SHOWING PROPOSED ADD: & ALTERATIONS.
ON PLOT NO 10 S.R. 7.

With reference to your application dated 4-12-34
with a plan for the proposed building/additions and alterations on plot
No. 10/2, Survey Sheet No. S.R.7, Serai Quarter
I have to request you to comply with the following requirements:—

AMENDED PLAN.
SHOWING PROPOSED ADD: & ALTERATIONS
ON PLOT NO 10/5.R.7.
SERAI QUARTER
SCALE 8-1.

FINAL PLAN.

Lambert B. W. L. S.
Land Manager & Architect

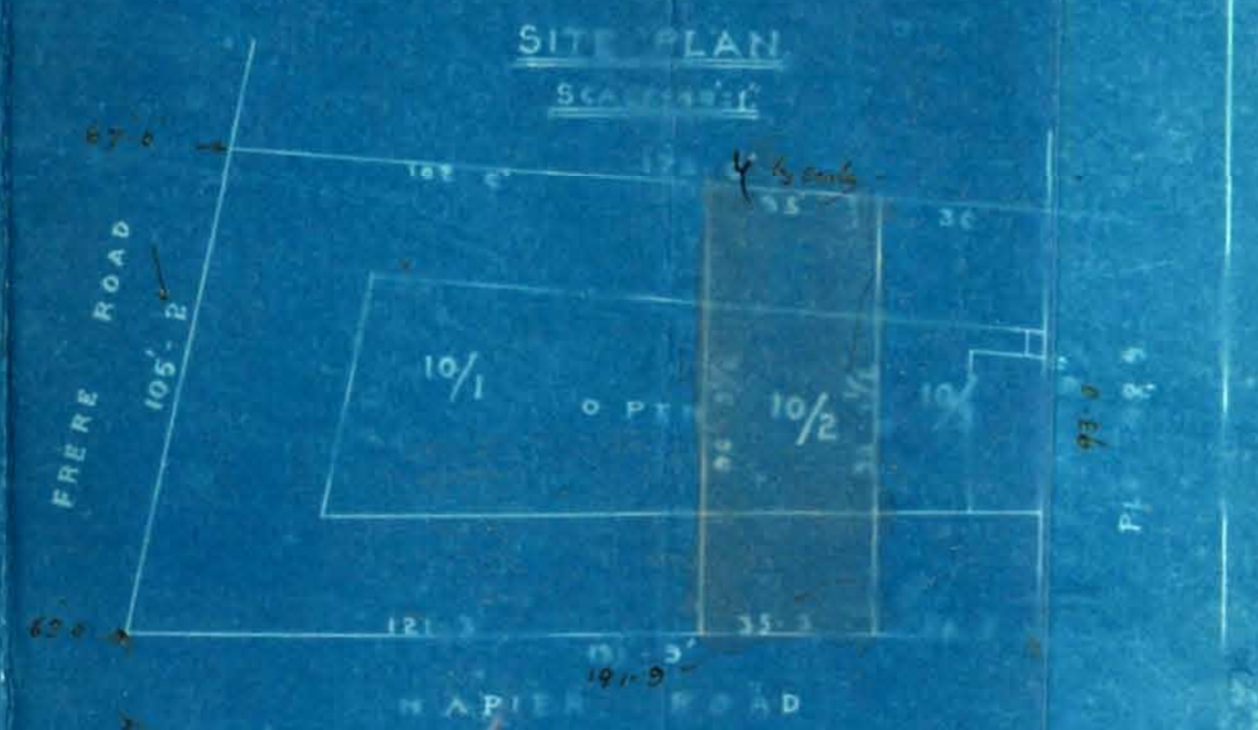
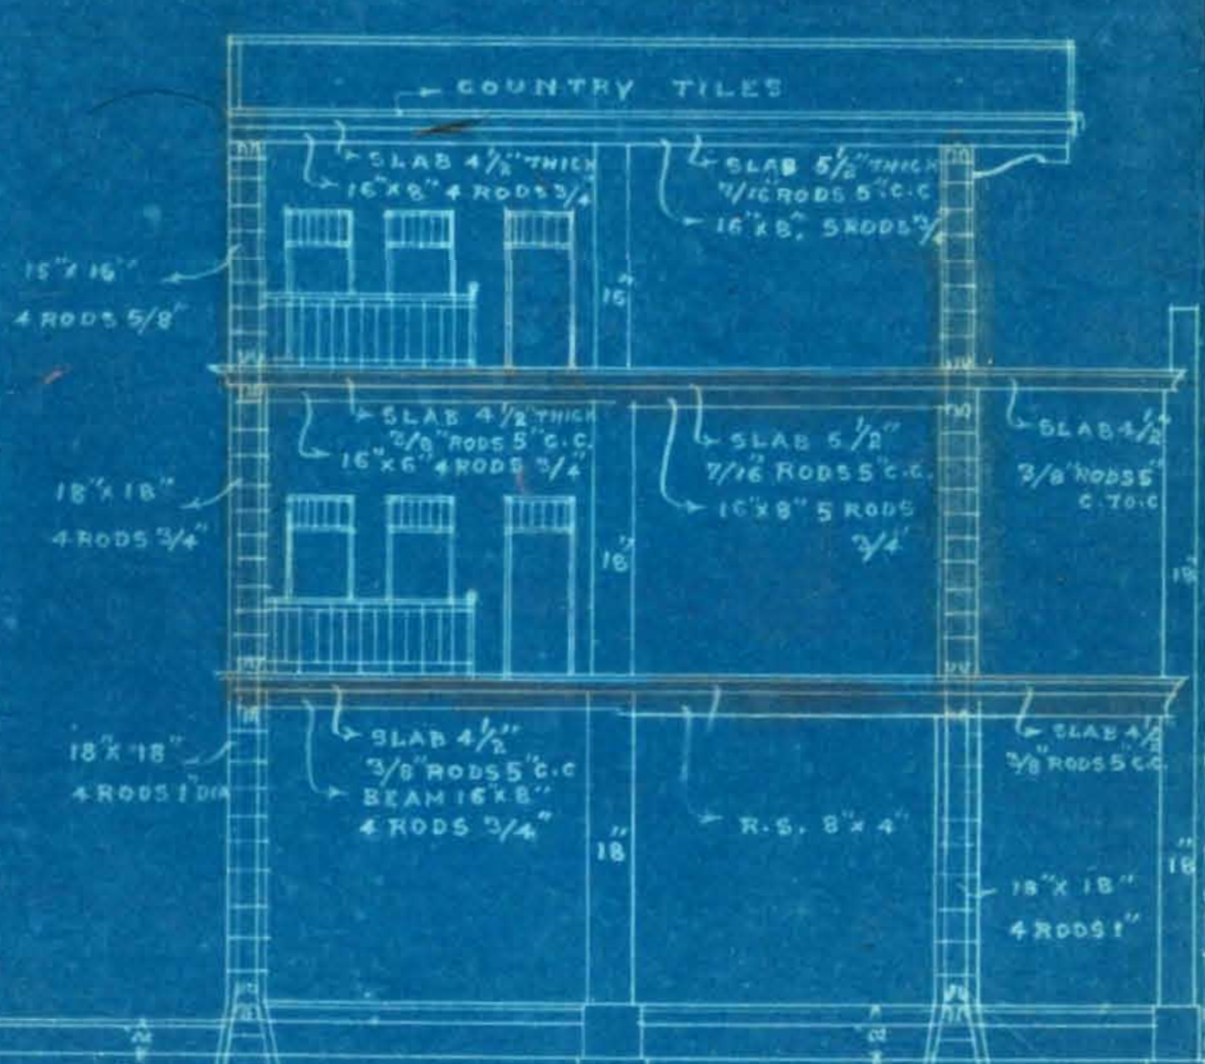
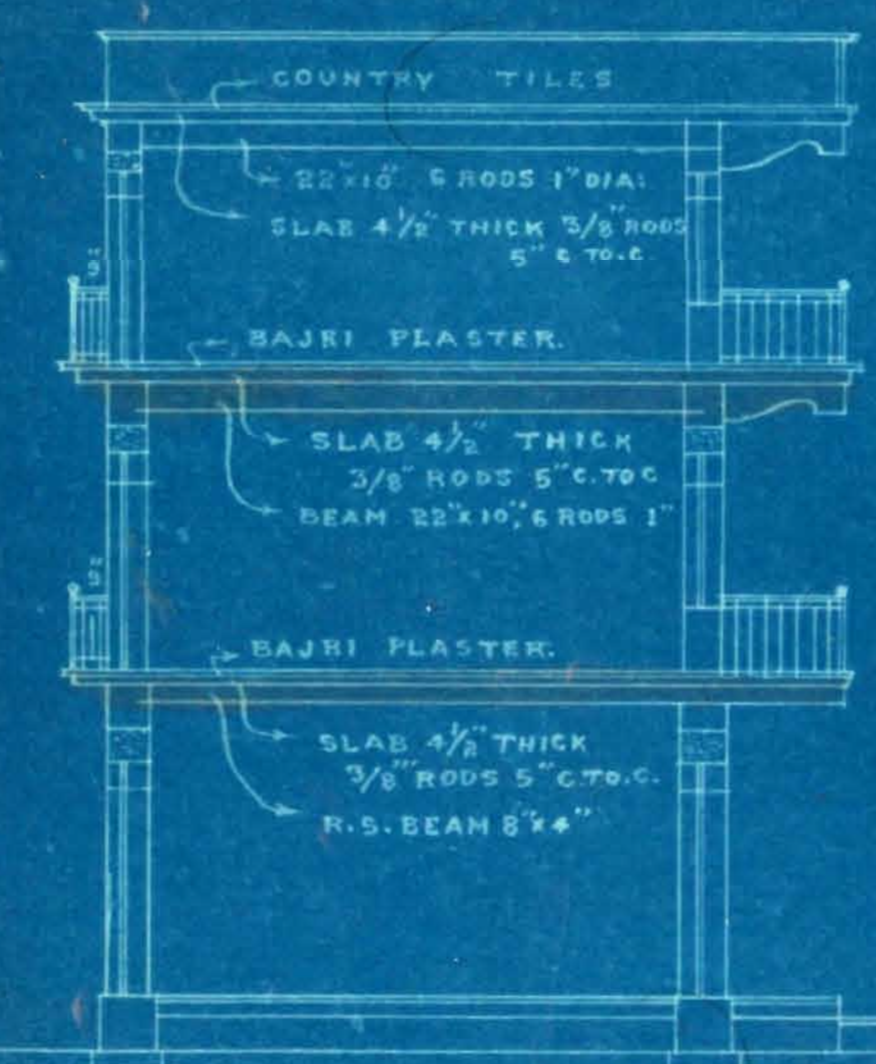
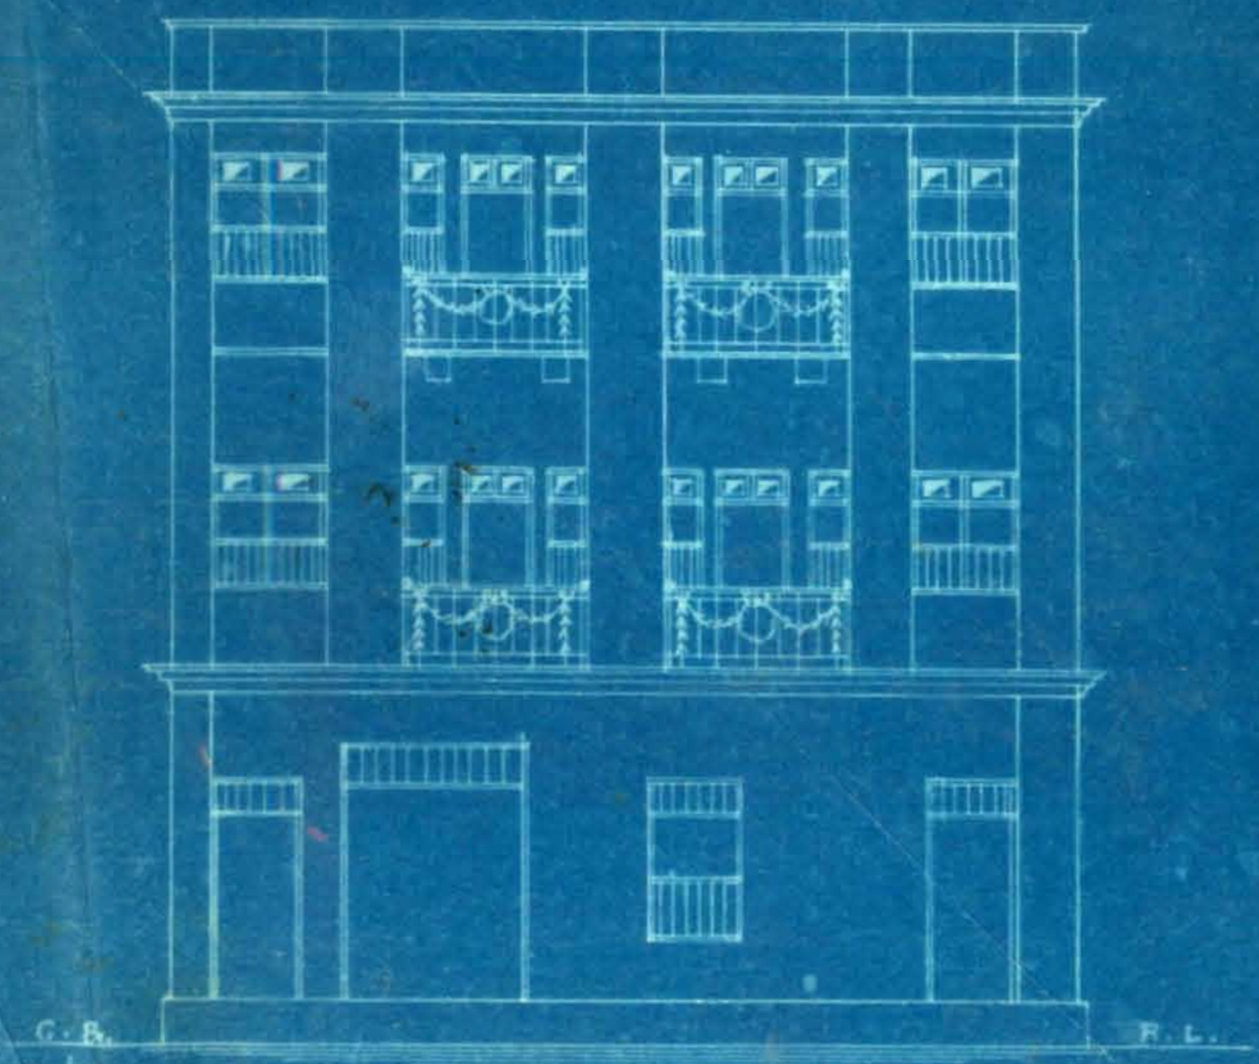
1. W.C. against rule above a ~~garage~~ godown.
- ✓ 2. The authority of subdivision must be produced.

With reference to your application dated 29-1-35
 with a plan for the proposed building/additions and alterations on plot
 No. 10/2, Survey Sheet No. S.R. 7 Serai Quarter
 I have to request you to comply with the following requirements:—

1. Requirements of the Health Officer must be complied with for which you are requested to please see him in the Office.

- ✓ 1. Requirements of the Health Officer must be
complied with for which you are requested to
please see him in the Office

B.S.P.C 298/34 dated 22 Dec 1934 regarding plan
of building on plot No: 10/2 sheet S.R. 7 Seral
Quarter we beg to state as under:-

1. Position of w.c. is same as shown in the approved plan.
2. With regard to the subdivision exam the same is shortly to be approved as practically there is no objection as the requirements of the City Deputy Collector's office have been complied with.

More over this being an amended plan we
trust you will pass the plan.

Sambucetto.Requirement has been
complied withplan approved
15/2no objection
14-2-35
